BCA REPORT
Concept Design Phase

Taronga Zoo
The African Savannah & Congo Precinct

Revision: 0
13 March 2017
Project No.: 160436

Figure 6: Existing Evacuation Diagram

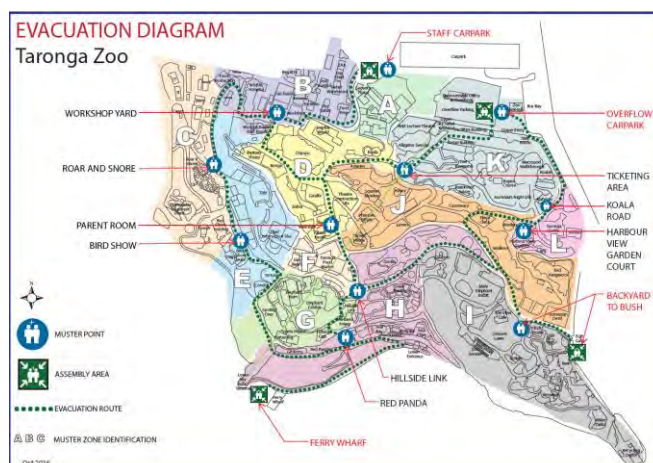
The Evacuation Plan will need to be updated upon completion of the proposed development in show the new works, revised egress paths and also the location of any new Muster Points that may have been re-positioned.

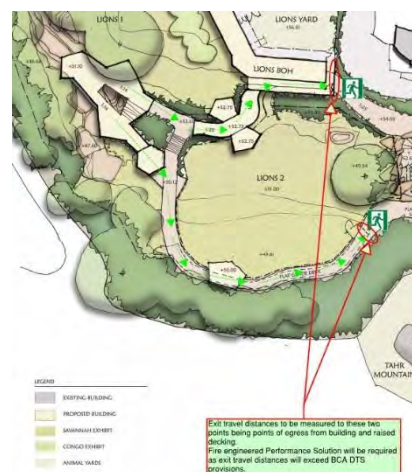
Exit travel distances have also been measured where external pathways require passing back within a building to access *open space* (as defined by the BCA), such as at the Lion Exhibit (Zone 2). In this regard, a fire engineered Performance Solution will be required to address the following:

- + Exit travel distances to one of two alternative exits measured from within the Lions Visitors enclosure is approximately 66m in lieu of BCA DTS maximum of 40m.
- + Distance between alternative exits is approximately 120m in lieu of BCA DTS maximum of 60m.

It is considered that the Performance Solution will take into account the following (unique) building characteristics in demonstrating compliance with the relevant BCA Performance Requirements:

- + There are no dead-end spaces (i.e. there are two points of egress available from all areas).
- + The primary reason why the BCA prescribes maximum travel distances for egress to ensure occupants are given sufficient time to evacuate the building prior to fire spread and the onset of untenable conditions. Other than the relatively small portion that passes below the Lion Den, the walkways are essentially open to the sky and therefore the risk of fire spread is significantly reduced, and there is no risk of the onset of untenable conditions as fire/heat/smoke will disperse to open air.
- + Unlike a typical building with enclosed spaces, rooms and corridors, there is a good level of visibility to the walkways and therefore a fire/smoke in a remote location can be sighted early and occupants can move in the opposite direction to a place of safety and not inadvertently towards the hazard.

Further consultation will be required with a suitably qualified Fire Safety Engineer in this regard.
